Product Change Notification / GBNG-02EIPE100

CCB 6067 Initial Notice: Qualification of STAR as an additional final test site for MICRF221AYQS and MICRF221AYQS-TR catalog part numbers (CPN) available in 16L QSOP (3.90mm) package.

PCN #: GBNG-02EIPE100

CCB 6077
Pre and Post Change Summary
PCN #: GBNG-02EIPE100

Pre and Post Change – Tape and Reel

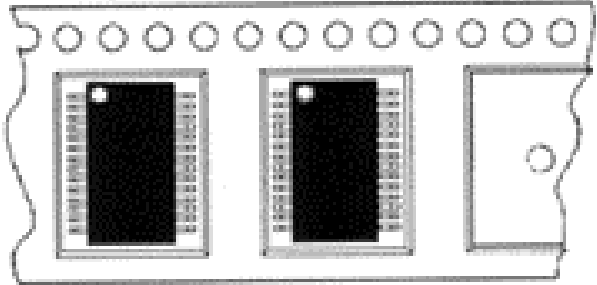
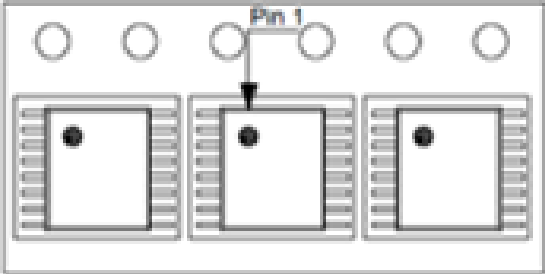
UNIS	STAR
BQM (Base Quantity Multiple)	2500 per reel	2500 per reel
Pin 1 orientation	 <p>Quadrant 1</p>	 <p>Quadrant 1</p>

Pre and Post Change – Plastic Reel

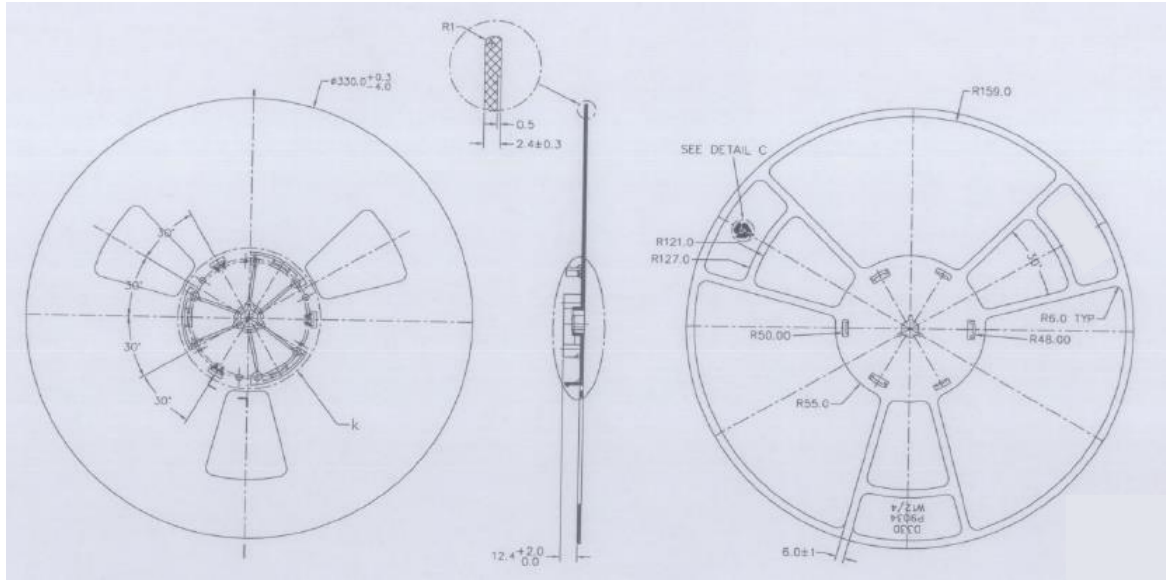
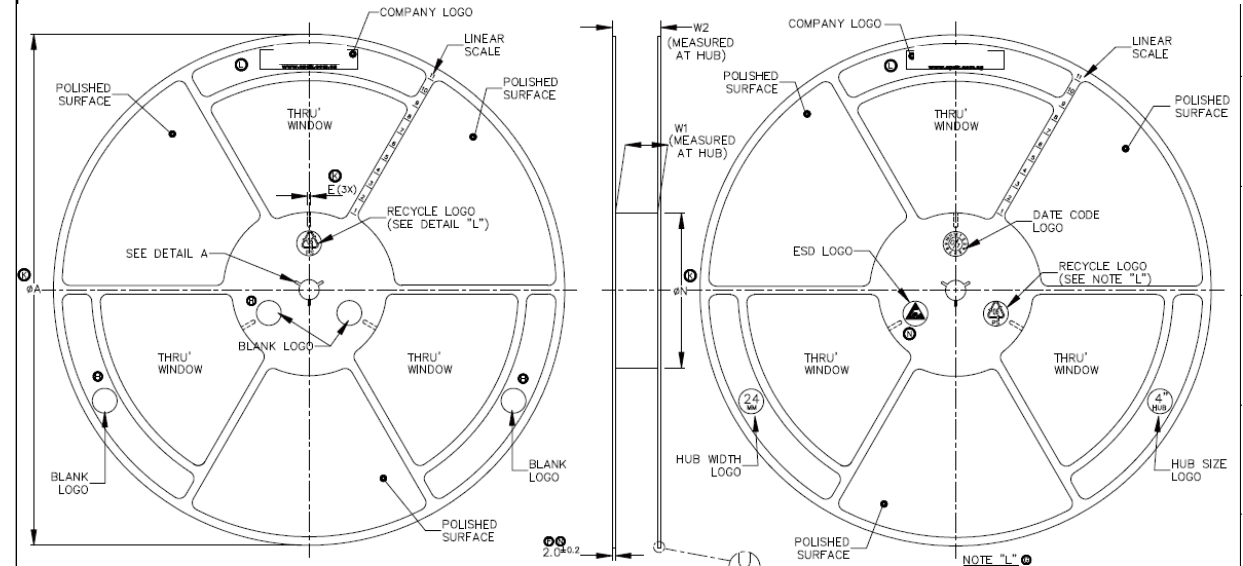
No dimension change.

Pre and Post Change – Carrier Tape

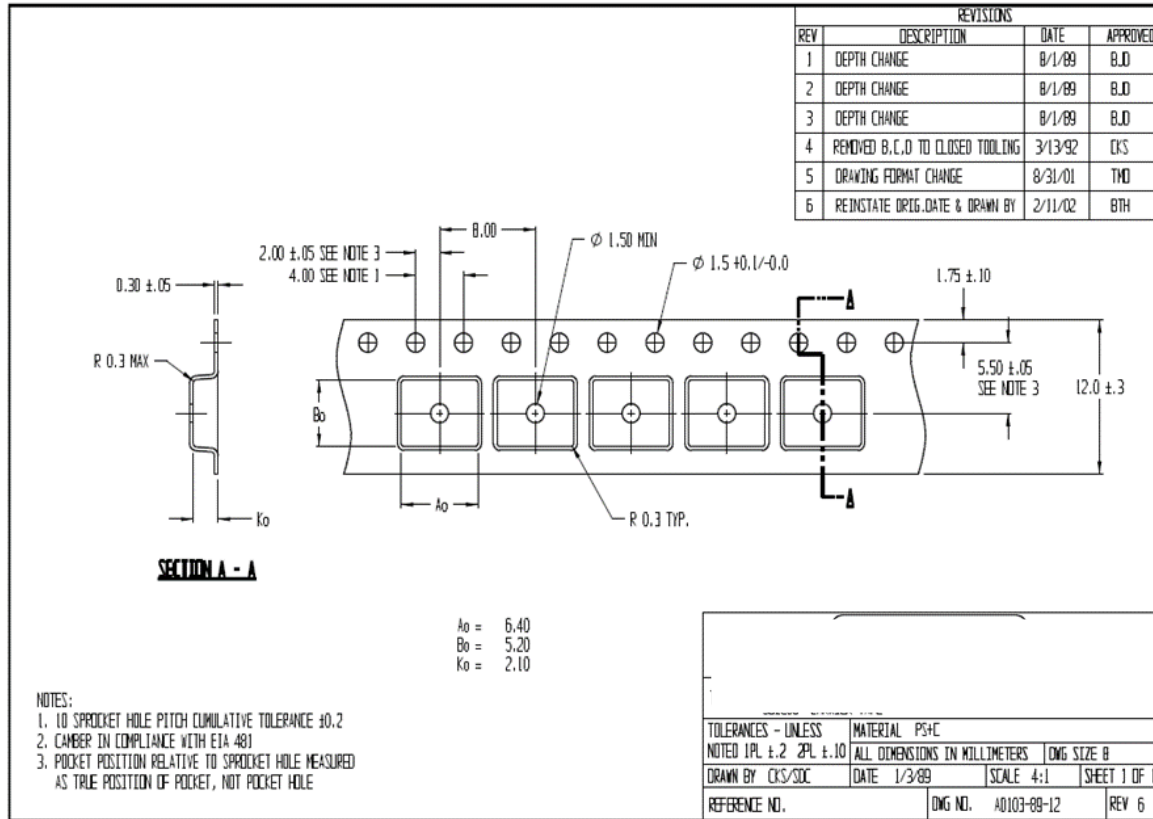
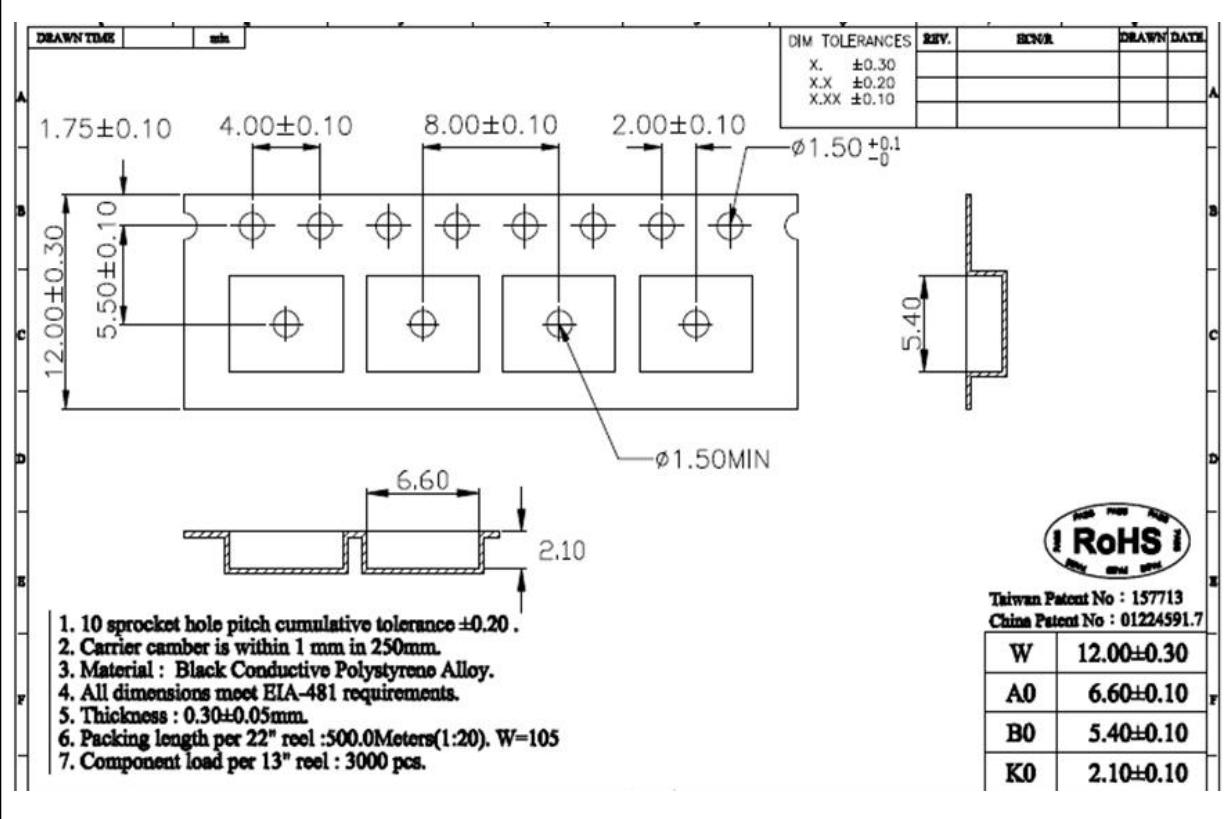
Plant	W (mm.) ± 0.3 or Specific	P (mm.) ± 0.1 or Specific	A ₀ ± 0.1 or Specific	B ₀ ± 0.1 or Specific	K ₀ ± 0.1 or Specific
UNIS	12	8	6.40	5.20	2.10
STAR	12	8	6.60	5.40	2.10

Pre and Post Change – Cover Tape

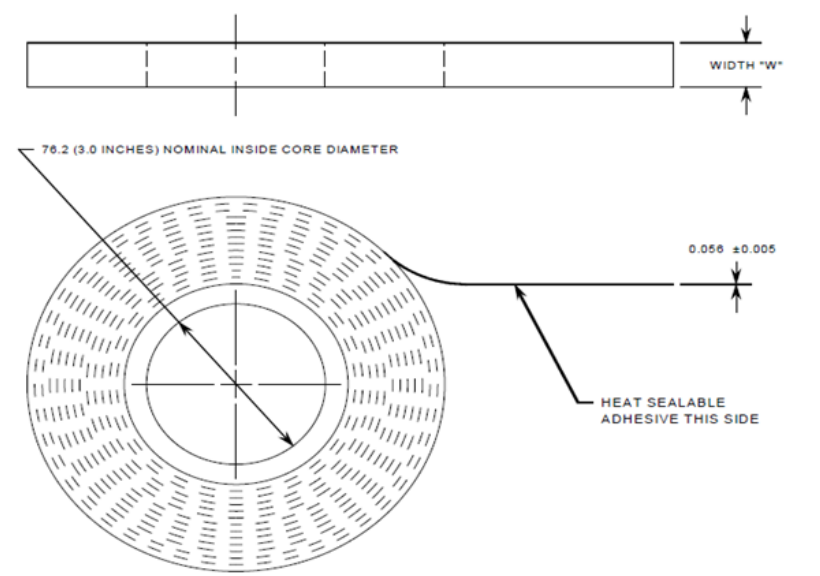
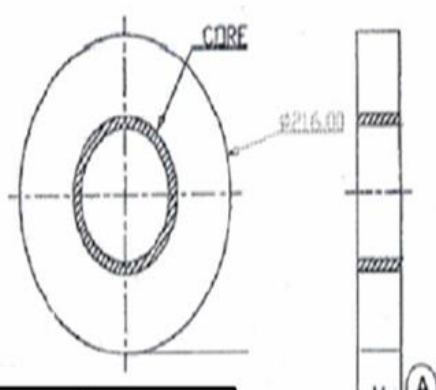
Plant	Carrier Tape Width	Cover Tape Width	Thickness	Color	Sealing mythology
UNIS	16mm	13.3 +/-0.1mm	0.056+/-0.005	Clear	Heat sealing
STAR	16mm	13.3 +/-0.2mm	0.050+/-0.005	Clear	Heat sealing

Pre and Post Change – Tube

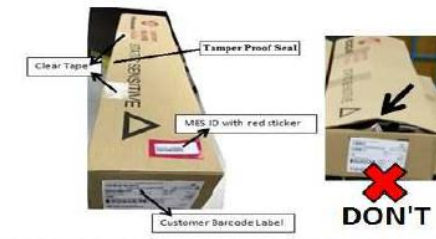
UNIS	STAR
BQM (Base Quantity Multiple)	98 units	98 units
Pin 1 orientation	<p>Pin 1 toward white stopper</p> 	<p>Pin 1 toward grey stopper</p> 
Tube Color	Clear tube	Clear tube
Plug Color	Full Tube: White – Black Partial Tube: White – Yellow	Grey-Grey
